UNITED STATES PATENT AND TRADEMARK OFFICE

APPLICATION NO.	FILING DATE	FIRST NAMED INVENTOR	ATTORNEY DOCKET NO.	CONFIRMATION NO.
09/934,178	08/21/2001	Brian J. Brown	S63.2N-5605-US05	8077

Office Action Summary

Specification

FIG. 3

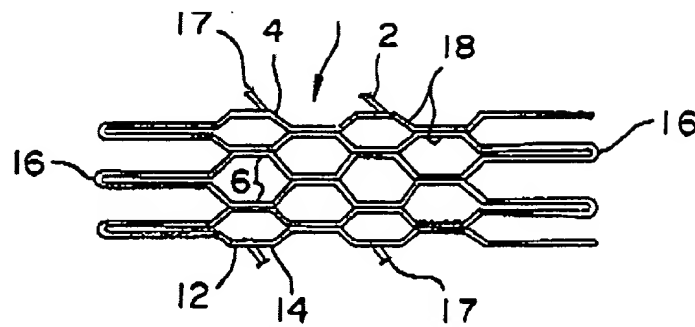
Claims 9-20 are rejected under 35 U.S.C. 102(e) as being anticipated by Kleshinski et al (US 5,902,317). Kleshinski anticipates the claim language where:

(1) the annular elements as claimed are the diagonal struts of wire (4) of Kleshinski;

(2) the struts of the ends are longer and inherently more flexible containing two strut straight struts such that the claim language is met requiring "a straight strut";

(3) the straight struts of the non-end diagonal struts of Kleshinski are all the same length such that the language requiring "all the straight struts of an annular element are of the same length" is fully met; similarly, the peak portions and valley portions of the non-end annular elements are all of the same length as required;

(4) the "at least one connecting member" as claimed is at least one of the straight portions (6) of Kleshinski;

(5) the fingers of the end segments of Kleshinski provide greater flexibility; see column 4, lines 3-20, Figures 1 to 5 and column 3, line 45 to column 4, line 67;

(6) the "end offset in a circumferential direction for the [other] end" as claimed is met by Kleshinski because the circumferential direction can be along the cell circumference.
